ADDENDUM NO.'S 1, 2, AND 3
TO THE
MASTER DRAINAGE MANAGEMENT PLAN FOR
PRIMROSE POINTE

PREPARED FOR:
S & S ASSOCIATES
OCTOBER, 1990
REVISED FEBRUARY 3, 1993

PREPARED BY:
COMMUNITY SCIENCES CORPORATION
CORRALES, NEW MEXICO
(505) 897-0000

ADDENDUM NO. 3
TO THE
MASTER DRAINAGE MANAGEMENT PLAN
FOR
PRIMROSE POINTE
(A PLANNED DEVELOPMENT IN NORTH ALBUQUERQUE ACRES
BERNALILLO COUNTY, NEW MEXICO)

FIGURE "E"

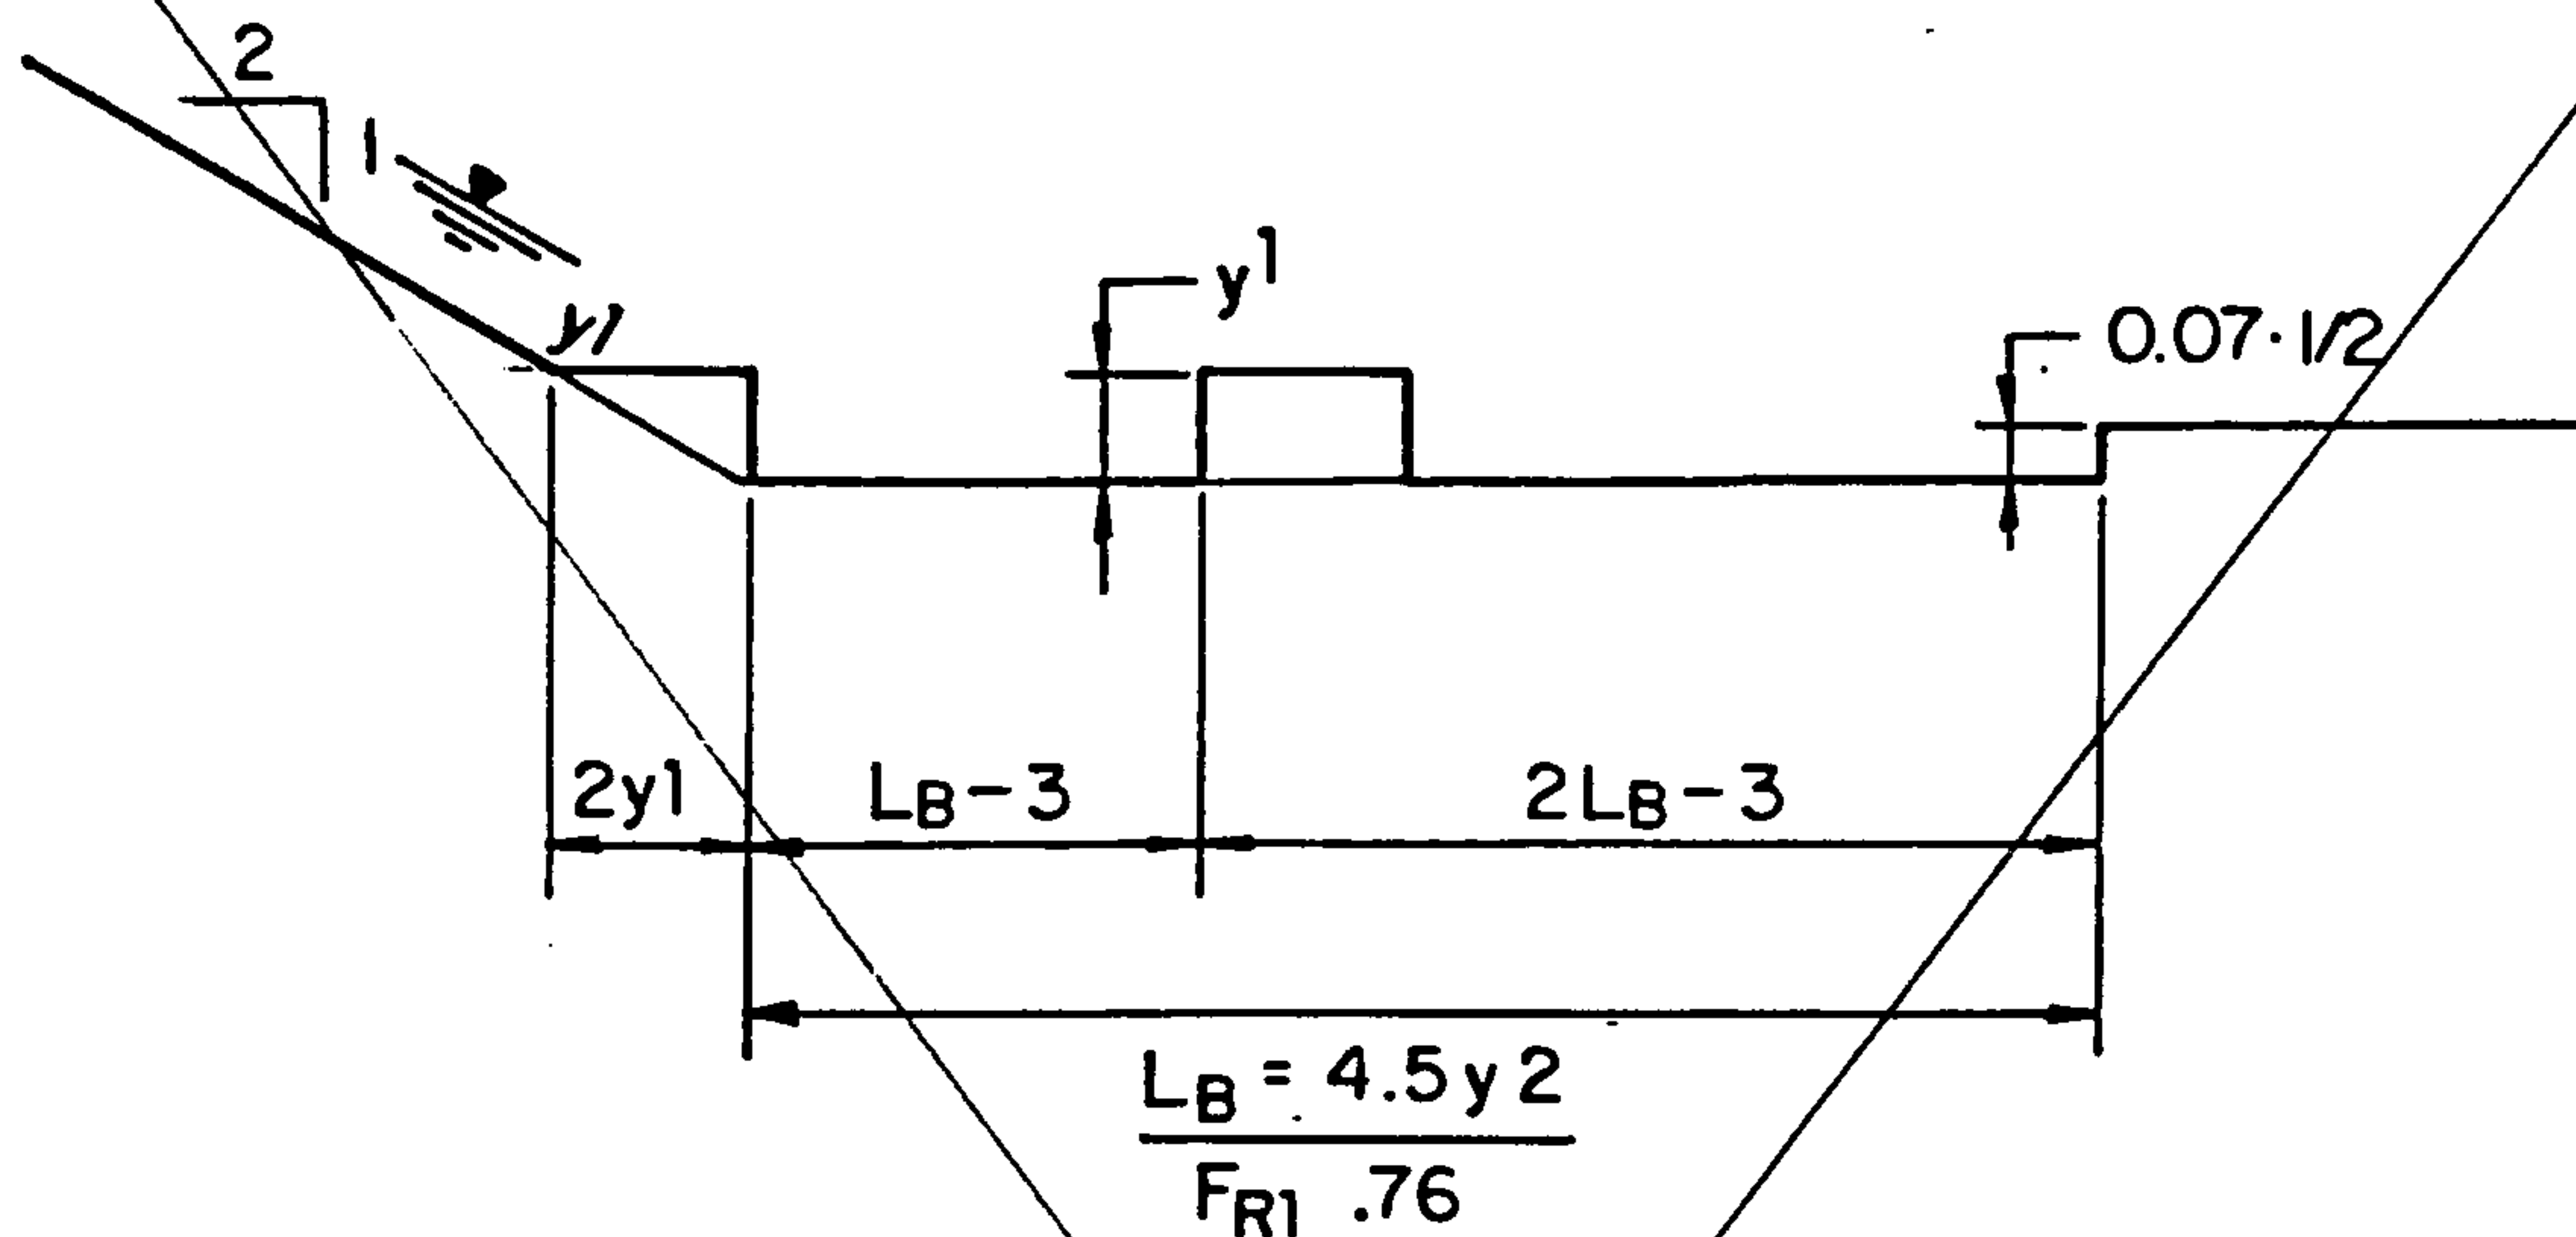
- d. Bank heights as originally calculated, including allowances for both super-elevation and freeboard, are to be used. (See the response to Comment No. G.2.b. on page 8.) Figure E at the back of Appendix B illustrates the fact that the energy grade line will be below that minimum top of bank elevation everywhere except right at the top of each drop structure, thus confirming the adequacy of the previous channel design.

- 15. "SUBCRITICAL FLOW AND HYDRAULIC JUMP CALCULATION PROCEDURE" (DELETED)**
- 16. FIGURE E (VOIDED WITH CHANGE IN DROP STRUCTURE TYPE AND REVISED PROFILE WITH NO SUBCRITICAL FLOW AND NO HYDRAULIC JUMP)**
